This is to certify that Ocean Ridge Realty Llc /n/a
has permission to Build New 6100 sq. Ft. Condominium Units # 13, 14, 15 and 16.
AT 840 Ocean Ave Portland, OR 97232 416A A003001

I have my completed the initial review and have the following questions/comments:

Re: OCEAN RIDGE CONDOMINIUMS **CC:** PAT TINSMAN, FILE

OCEAN RIDGE CONDOMINIUMS
852 OCEAN AVENUE
PORTLAND, MAINE

(A) 1 HR. FIRE RATED DEMISING WALL
1'-11\"/>

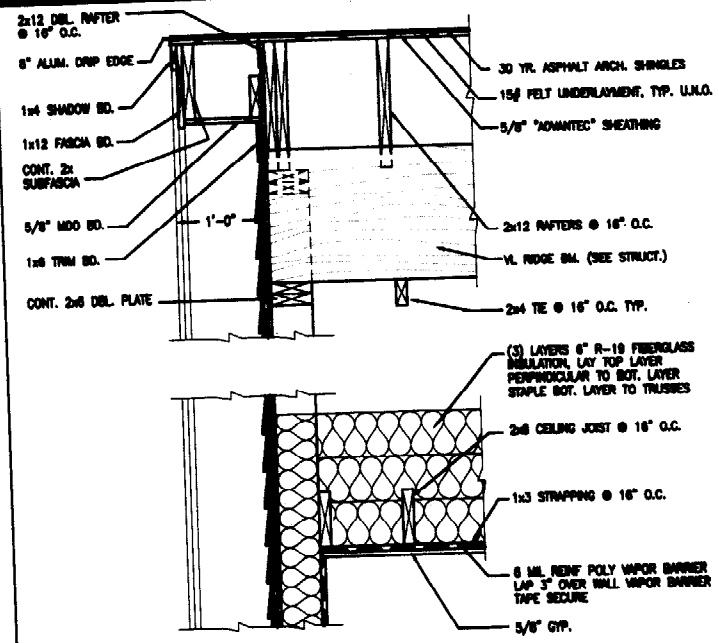
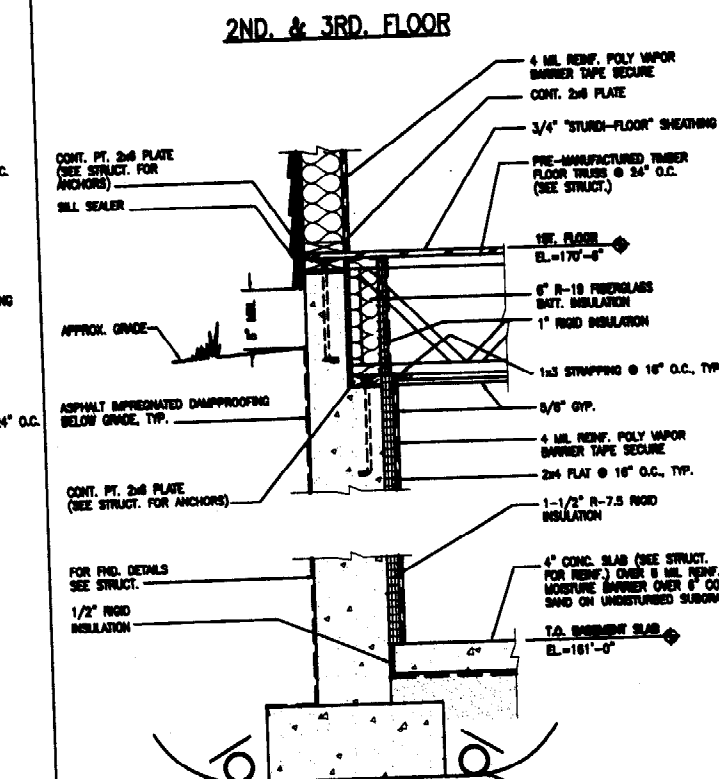
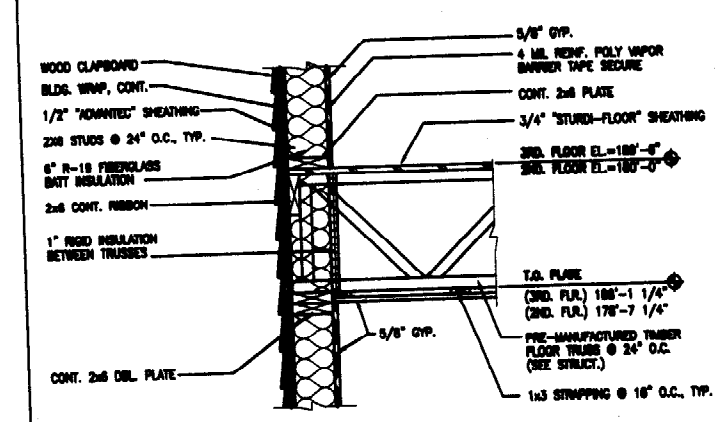
- 9) Does the wall system extend to the underside of the roof sheathing?
- 10) What is the STC of the wall assemblies?
- 11) Page S9 Figure 5, using the FTW product, does the fire rated assembly include the GWB on the underside of the floor? (see section 711.4)

STC Issue—Do all of the tenant separation assemblies have an STC of 45 or greater?

- 9) The Fire Rated Wall systems extends to the underside of the exterior roof sheathing typically as shown on Details1 /A9 & Detail A/A10.
- 10) The STC of the Rated Fire Wall as shown on drawing A10 is 50-55. The other walls are between 30-35 depending on insulation and sheathing materials. If you need specific wall STC documentation, please contact this office.

- 3) An STC of 50-55 will apply for all the unit demising walls (refer Section A/A10)
